Re: Takoma Junction Development, Montgomery County, MD
SHA Tracking #19APMO008xx

RE: Takoma Junction
MDOT SHA Tracking # 19-AP-MO-008-xx
Our Job No.: 2016-0409

This letter has been prepared to respond to comments received from the Maryland Department of Transportation State Highway Administration (MDOT SHA) in a letter dated June 16, 2021, in reference to the review of the Concept Plan for the Takoma Junction development.

EXHIBIT A: WB-67 Pull -Into Lay-By-Lane

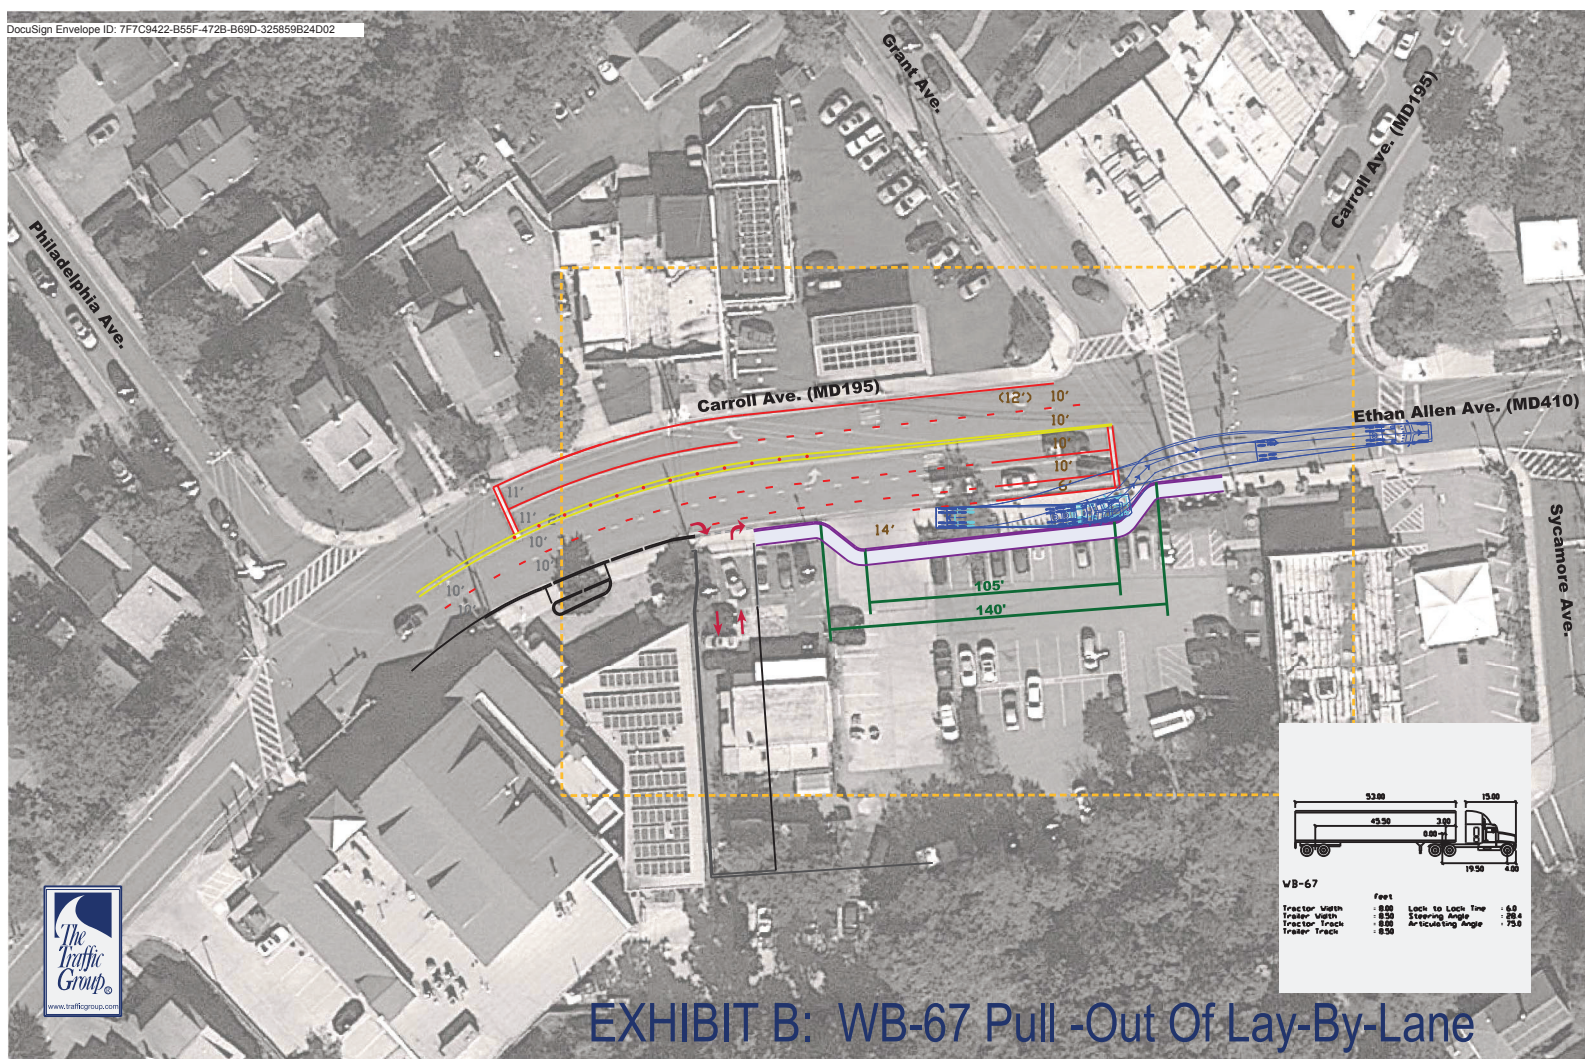
- Please note continued concerns with regards to trucks parked in the layby overhanging the adjacent bicycle and travel lane. This situation cannot be endorsed. Also note that insufficient stopping sight distance would further exacerbate the related safety deficiencies.

- With regards to trucks requiring multiple maneuvers to park within the layby, please note that there is a proposed transit bus stop at the rear end of the layby. Multiple truck maneuvers within the layby to park, exposes pedestrians and cyclists to the rear blind spot(s) of these vehicles and increases the safety risk, particularly to pedestrians. The increased safety risk within this confined area of the roadway is not supported. It is inconsistent with current pedestrian safety initiatives within the area.

Response – Longer Layby: Per Exhibit A, the Developer has increased the depth of the layby from 12' to 14'. This will allow a truck to clear the adjacent bicycle and travel lane in a single move eliminating any concern related to a back-up maneuver to align within the lane, as well as any further safety concerns.

Response – The Developer has increased the width of the layby from 12 feet to 14 feet. See attached Exhibit A showing that large semi-trucks can now pull into the layby lane in one maneuver without overhanging and blocking the bike lane or traffic lane. Exhibit B shows the semi-truck backup up slightly to exit the layby lane.

STOPPING SIGHT DISTANCE

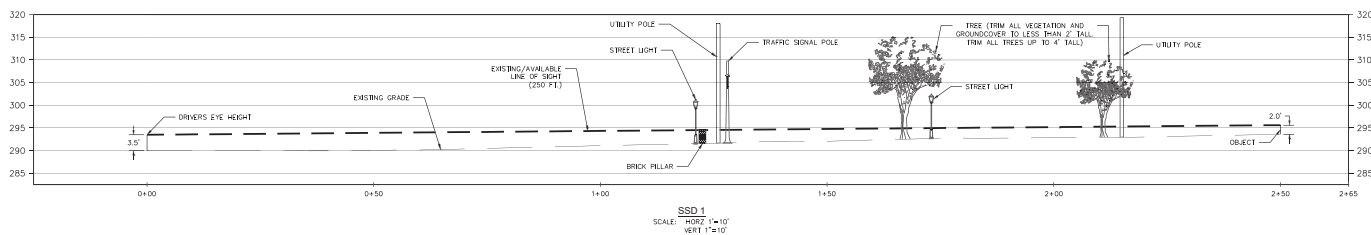
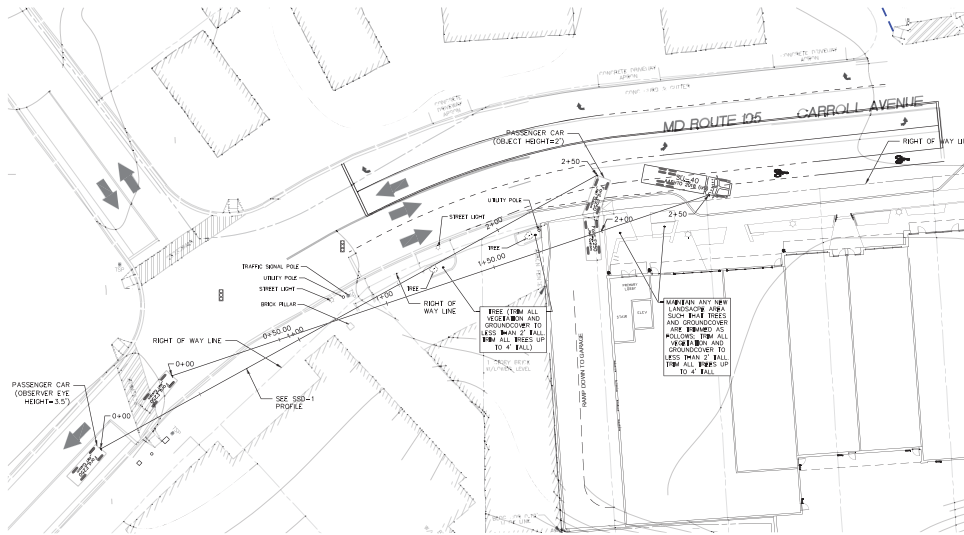
Comment No. 4 – Please note that the safety issues identified in the letter of May 17, 2021, have not been adequately addressed with respect to the measurement and reporting of the proposed sight distances.

- Sight distance measurements should be repeated following industry standard practices. Where deficiencies are observed, a list of options should be prepared for review and consideration.
- A sight distance profile should be prepared along the measured line of sight. The profile should clearly identify any obstructions including shrubs, trees, structures, utilities and conflicting roadway elements where they occur along the profile. The line of sight traverses the roadway, sidewalk, and an area behind the sidewalk.

All trees will be removed or trimmed, providing our Access Point the ability to meet AASHTO minimum "Stopping Sight Distance" guidelines. See Exhibit D.

Please note: the obstructions that exist currently block safe stopping sight distance to existing traffic vehicles queued back from the traffic light at the eastern signal. The minimum safe stopping sight distance of 250 ft can be achieved with the removal or trimming of the trees. See Exhibit D.

Response – A sight distance profile of the proposed line of sight is attached (prepared by AMT). The existing vegetation will be removed/adjusted to remove them as obstructions. As acknowledged in the Prime AE Sight Distance exhibits provided by MDOT SHA, Carroll Avenue roadway does not have a vertical curve alignment issue. However, we can agree a profile could help define the minimum amount of existing vegetation that needs to be trimmed to provide safe stopping sight distance along eastbound Carroll Avenue. The attached profile shows the minimum 250 ft stopping sight distance is achievable with the removal or trimming of trees.

The minimum safe stopping sight distance of 250 ft can be achieved with the removal of the vegetation. See Exhibit D and the AMT profile.
